Santa Ana River Wasteload Allocation Model Update

BASIN MONITORING PROGRAM TASK FORCE

November 16, 2017

Response to Comments on TM No. 1

Figure 28

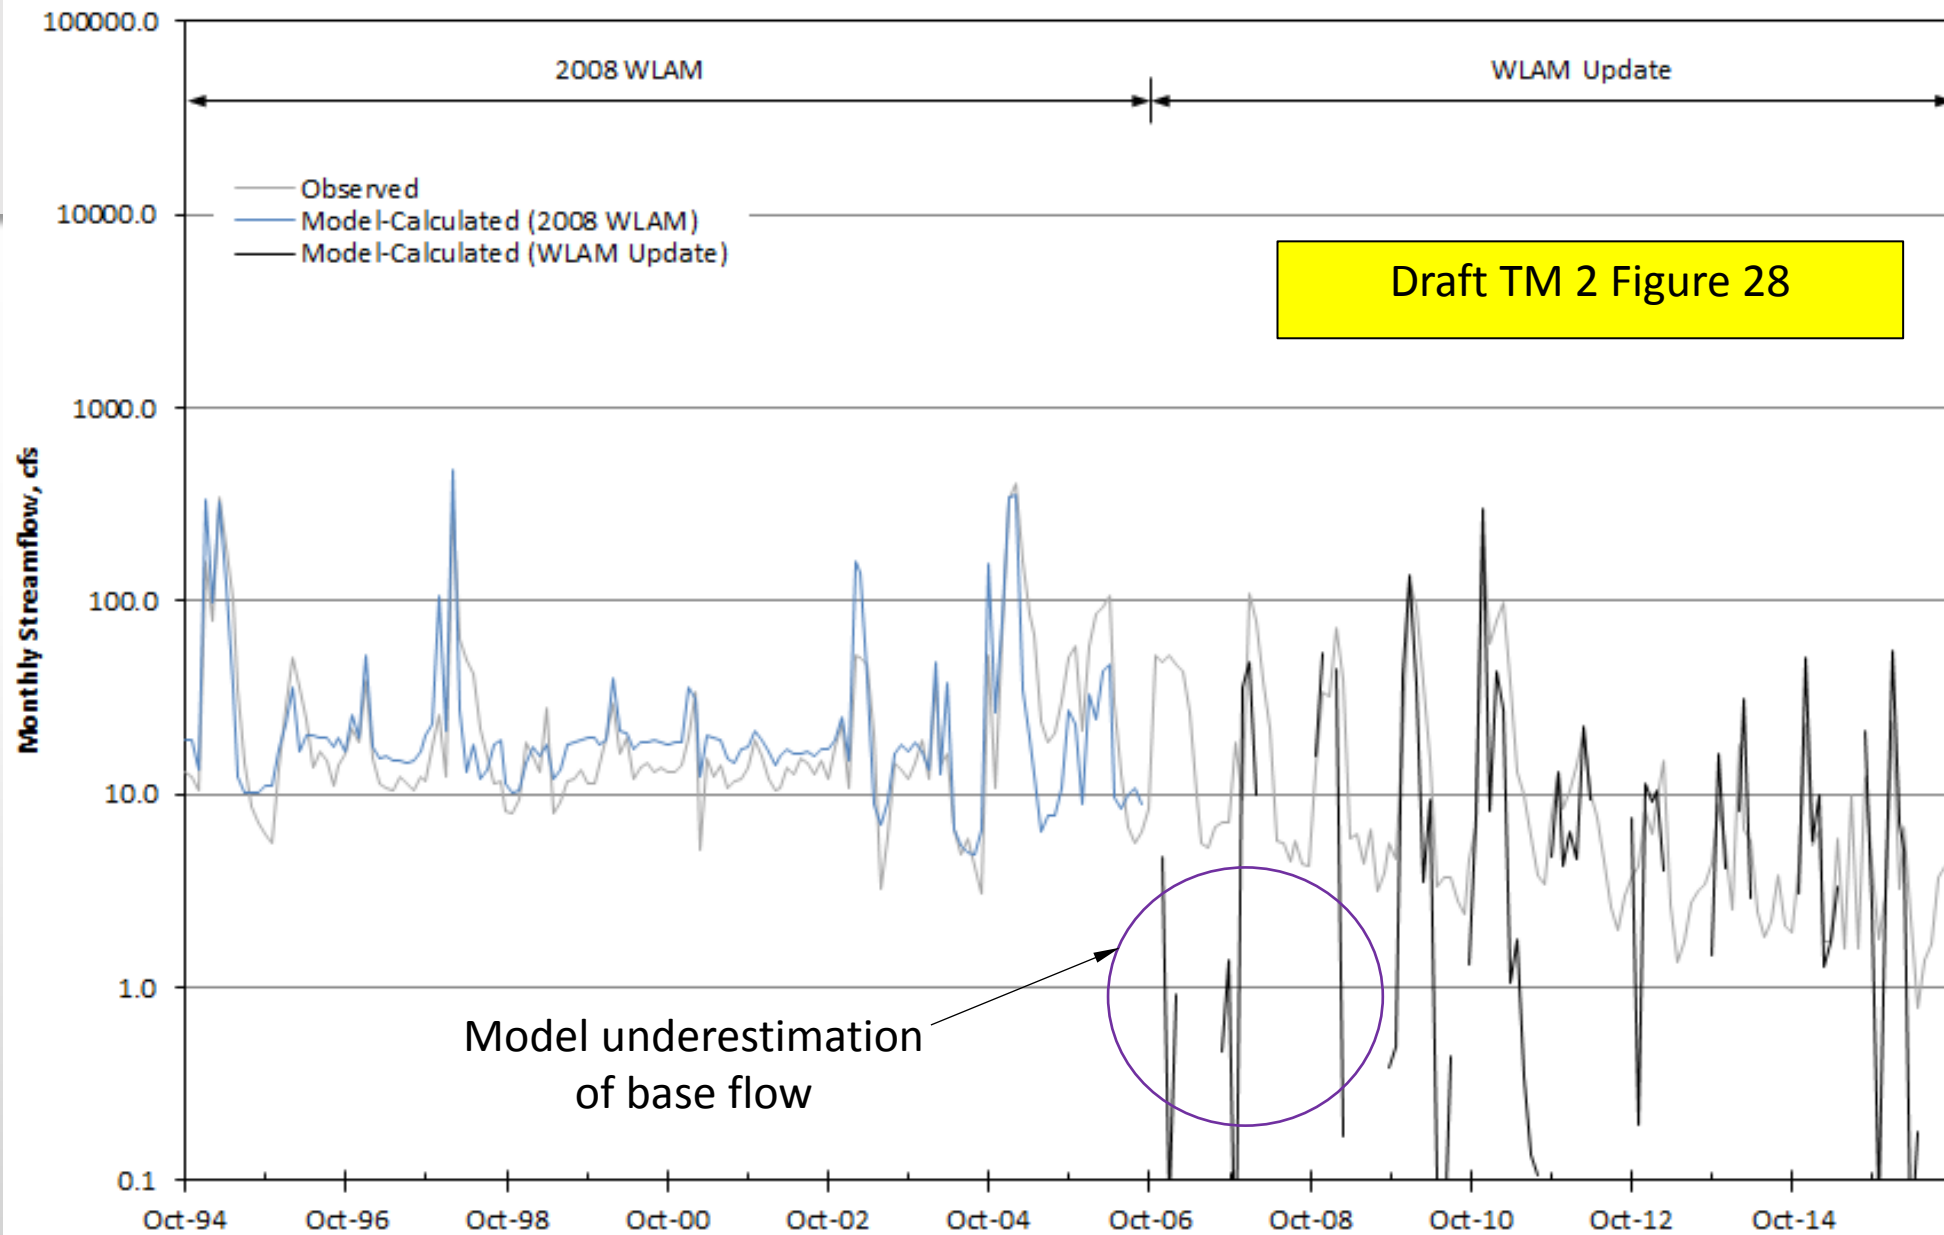
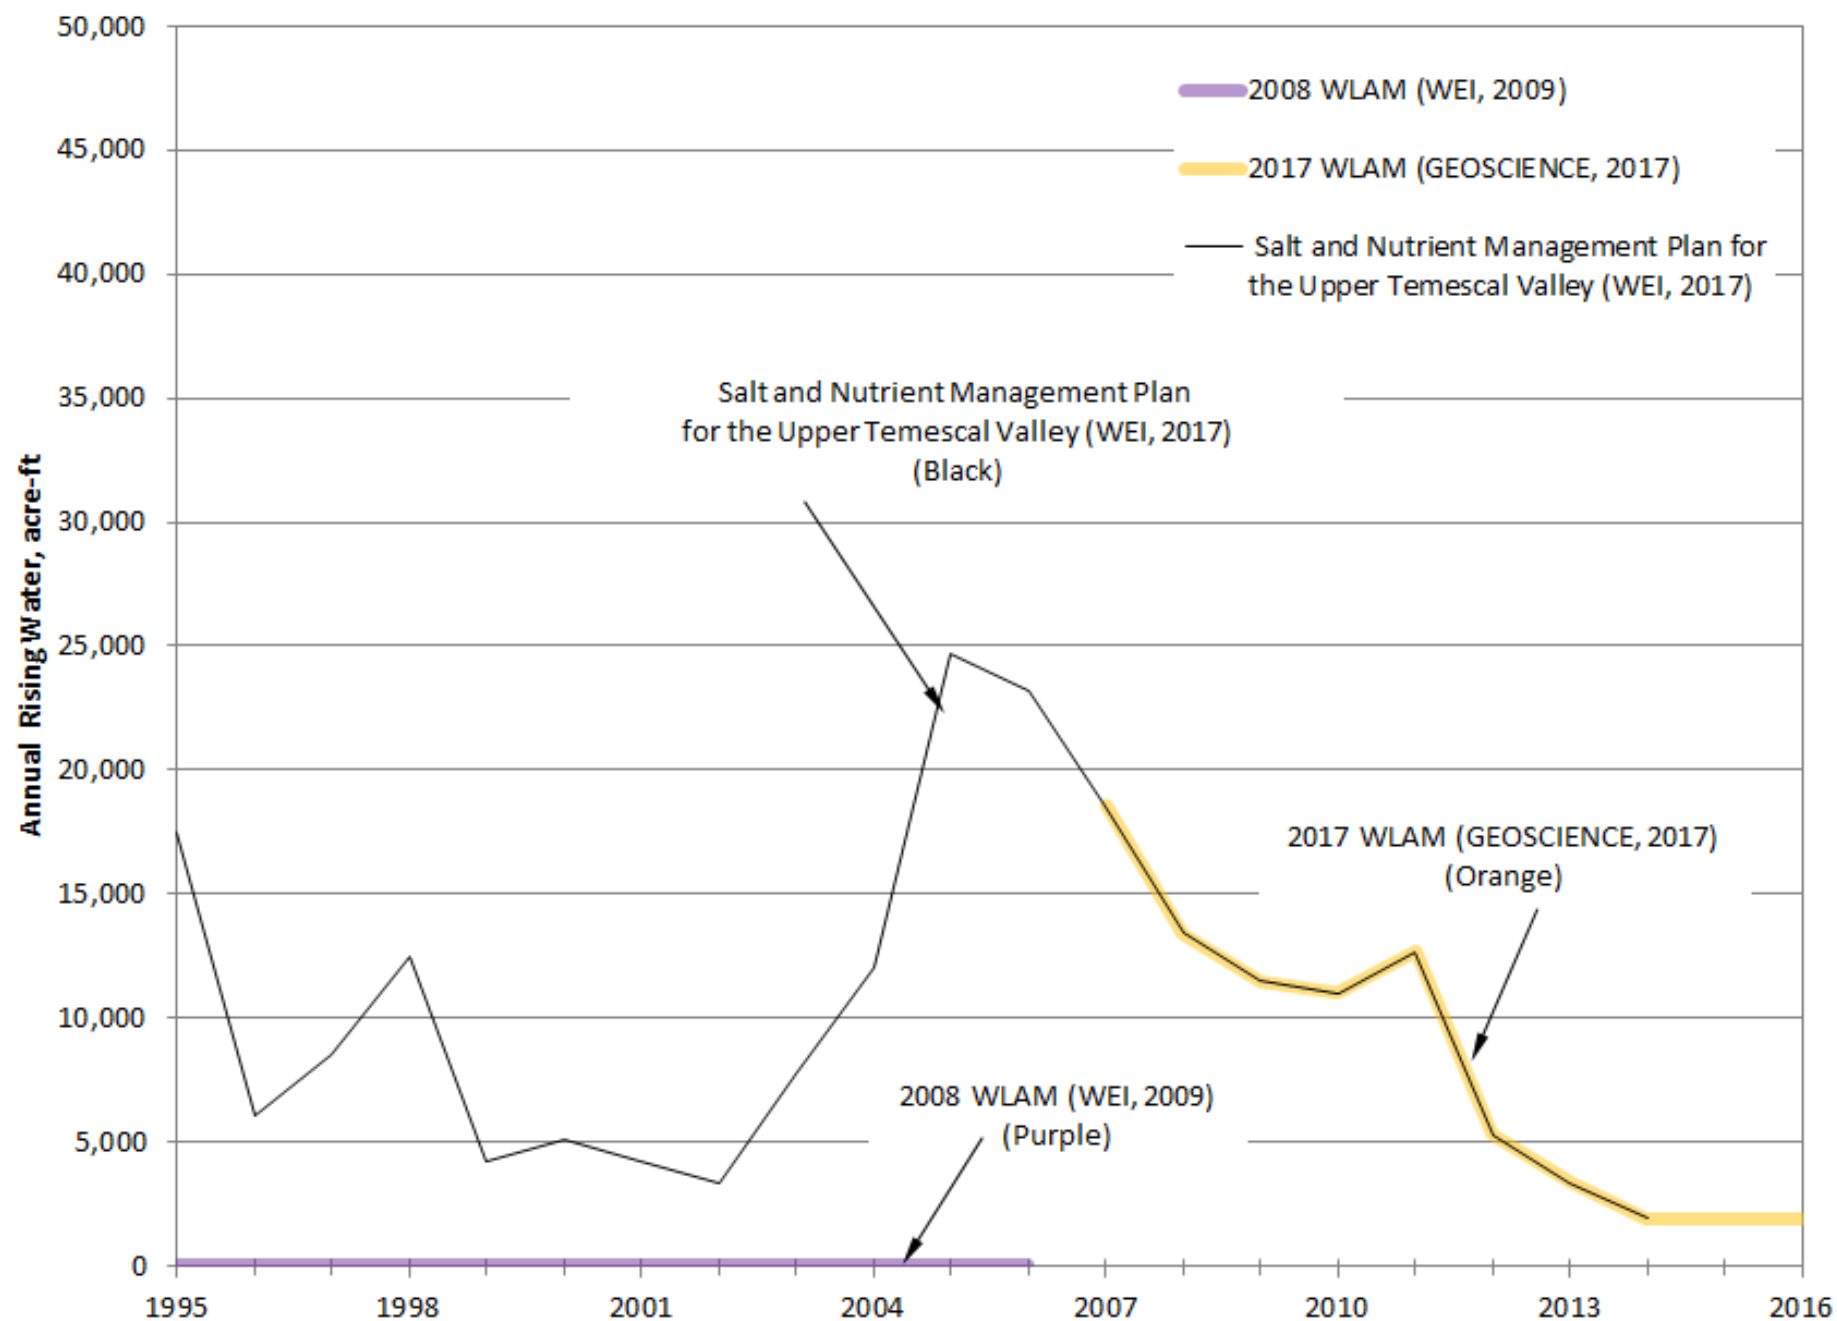
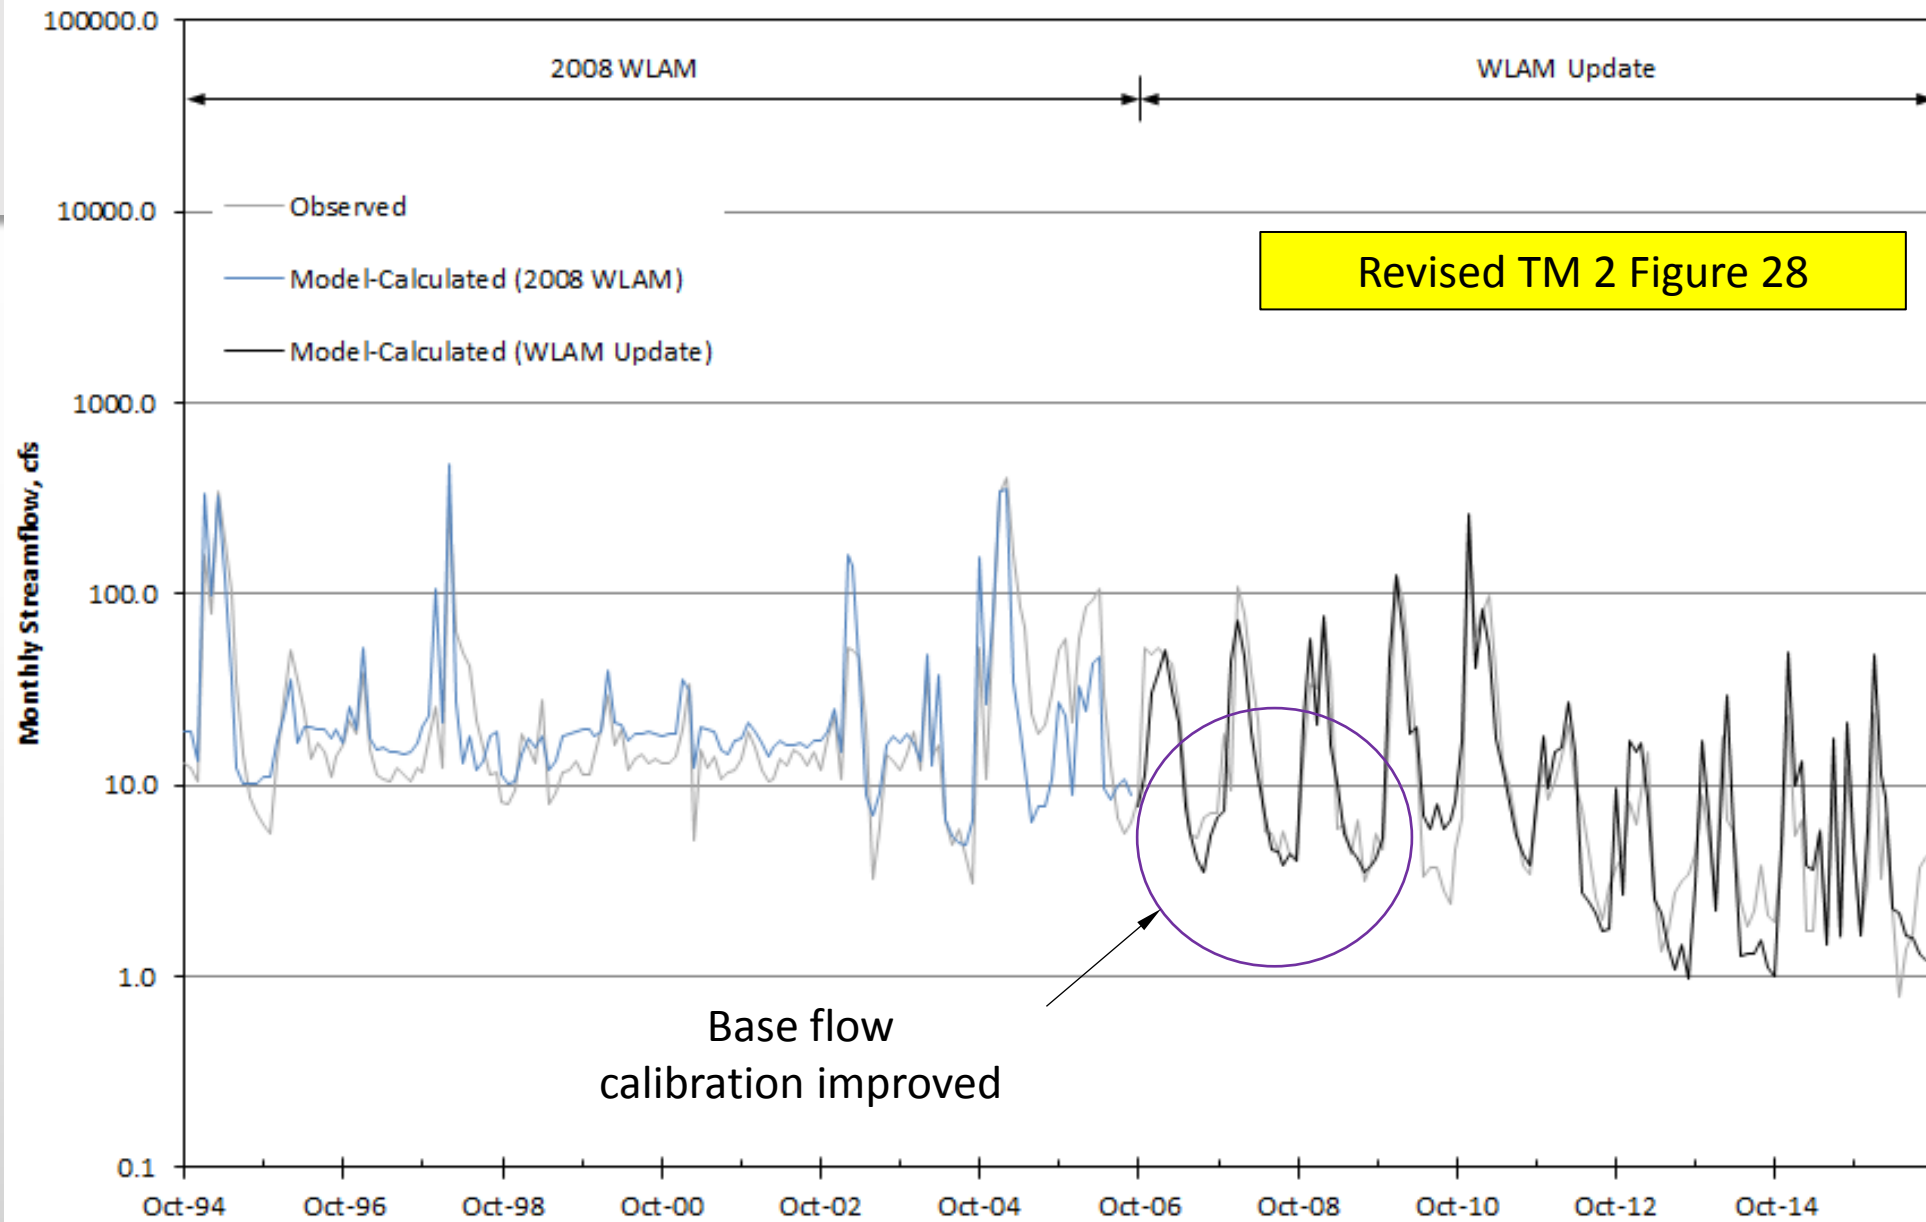
No.	Section	Pg.	Comment	GEOSCIENCE Response
7	3	12, 15	Page 12 & 15. The first sentence states that the calibration is a trial and error process until a "reasonable" match is met between model simulation and actual flows. However, some calibration results indicate a rating of Poor with the new WLAM model. Please explain why a "Poor" R2 level is considered a "reasonable" or "satisfactory" match. Please explain.	The poor calibration for monthly streamflow at Temescal Ck at Main Street has been addressed. The poor calibration for daily streamflow at Santa Ana River at Santa Ana is a product of the modeling process. Flow at this location is largely from the OCWD recharge facilities model, which simulated Prado Dam operations. Actual releases from Prado may be different, which causes a discrepancy between the modeled and observed streamflow at this location. Additional explanation to this effect will be added.

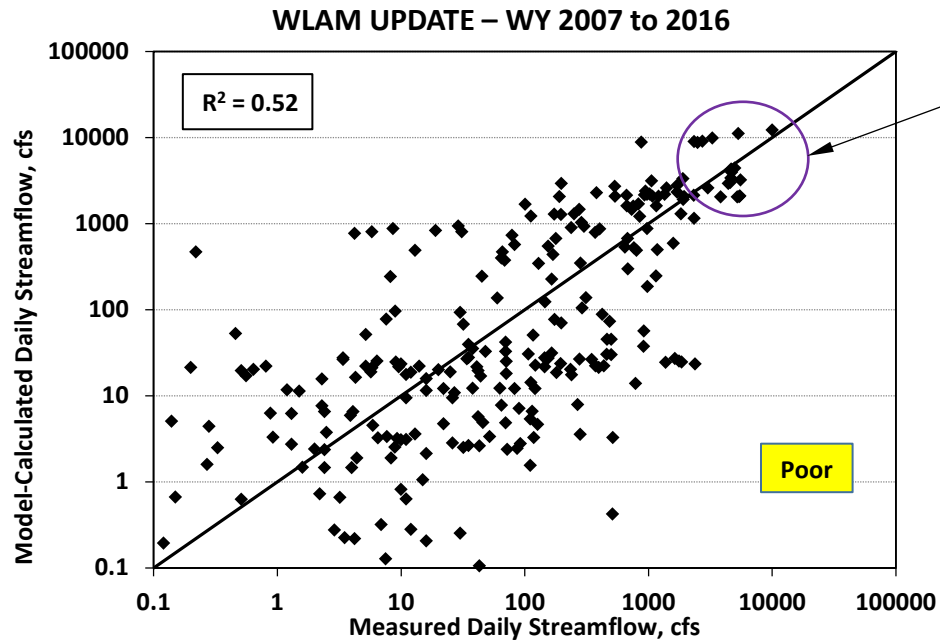
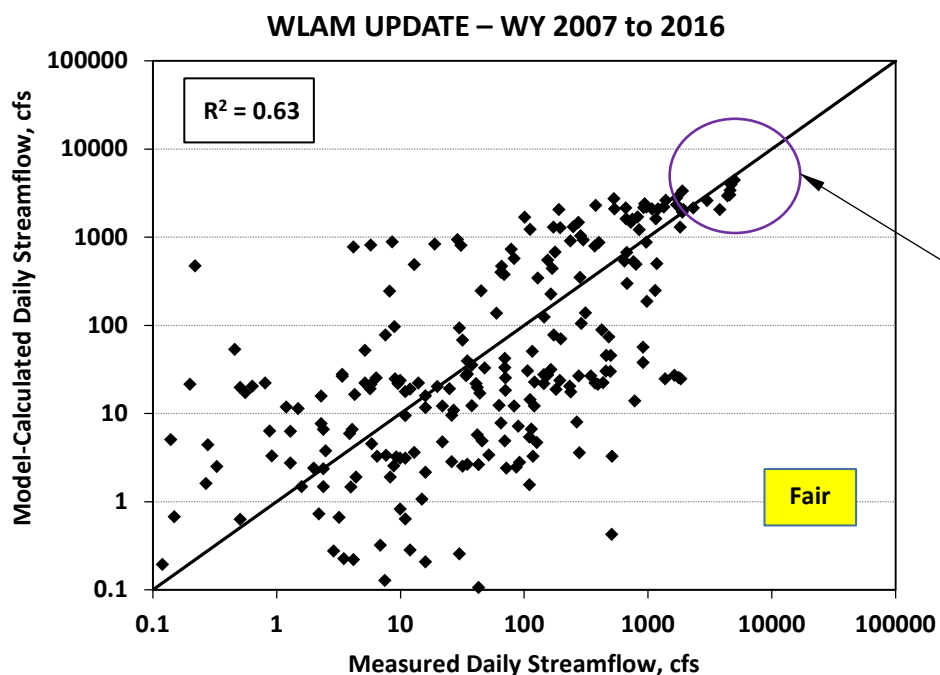
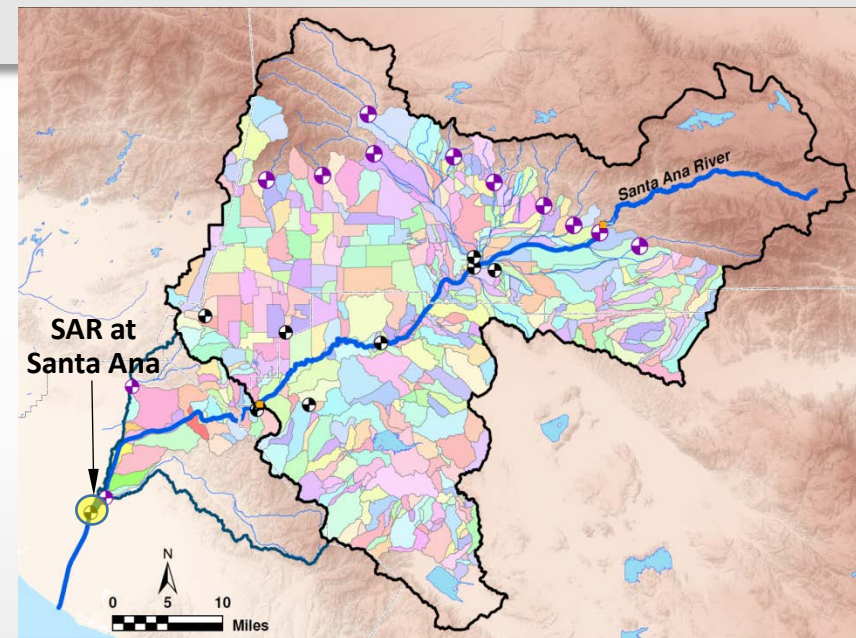
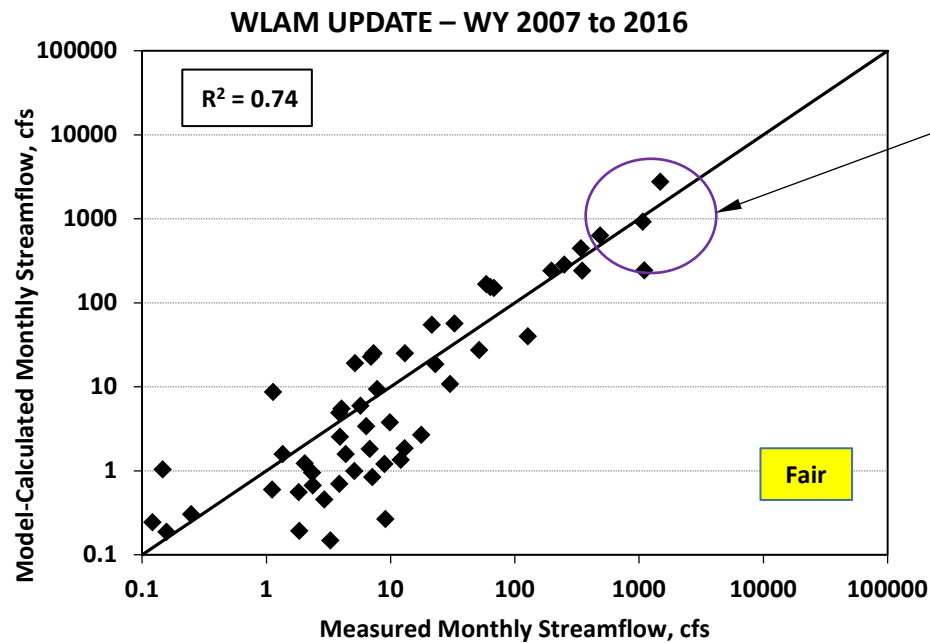
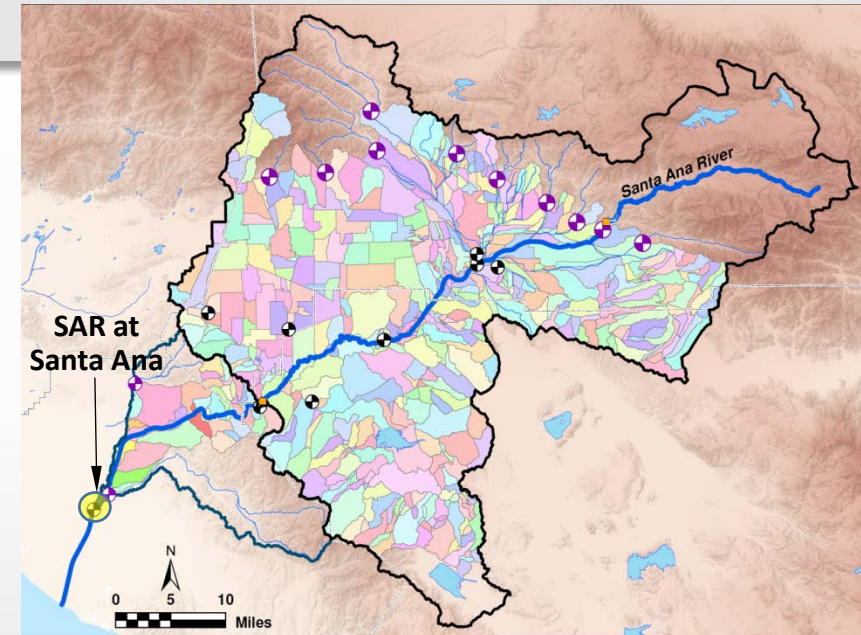
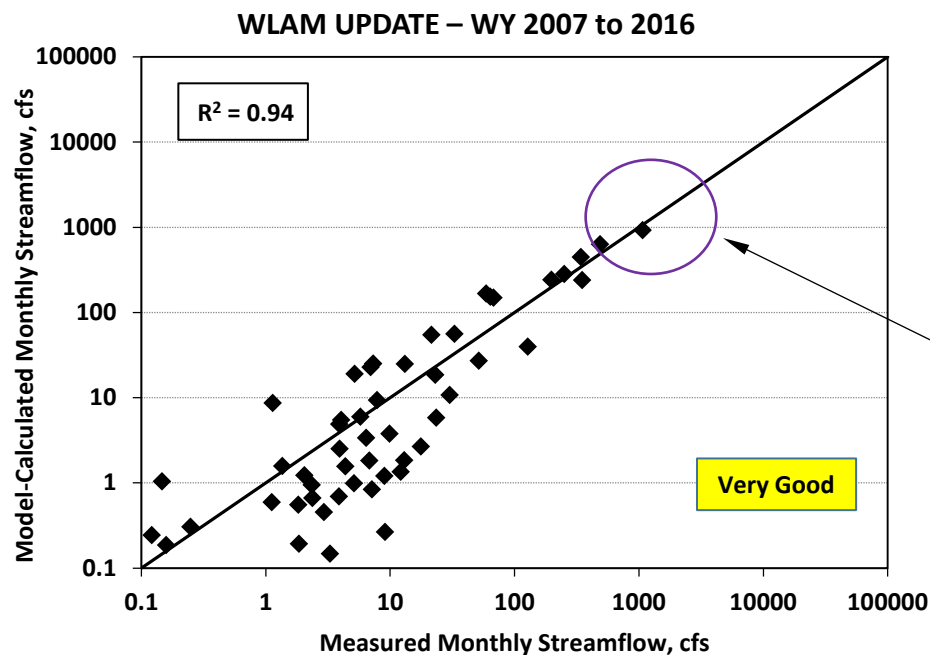
Model overestimates flow
in December 2010 and
underestimates flow in
January 2011

Model overestimates flow
in December 2010 and
underestimates flow in
January 2011

No.	Section	Pg.	Comment	GEOSCIENCE Response
5	3.3	15	Provide an explanation for the poor model performance at the Santa Ana River at Santa Ana gaging station.	The 2008 WLAM used the gaging stations at Santa Ana River at MWD Crossing and Santa Ana River below Prado Dam for the TDS/TIN calibration, due to data availability. These same stations were utilized in the 2017 WLAM HSPF version, but an additional gage was added (Santa Ana River at Imperial Highway near Anaheim) due to the extension of the model into Orange County.

Calibration improved after data
between December 19, 2010 and
January 11, 2011 were removed

Calibration improved after data
between December 19, 2010 and
January 12, 2011 were removed
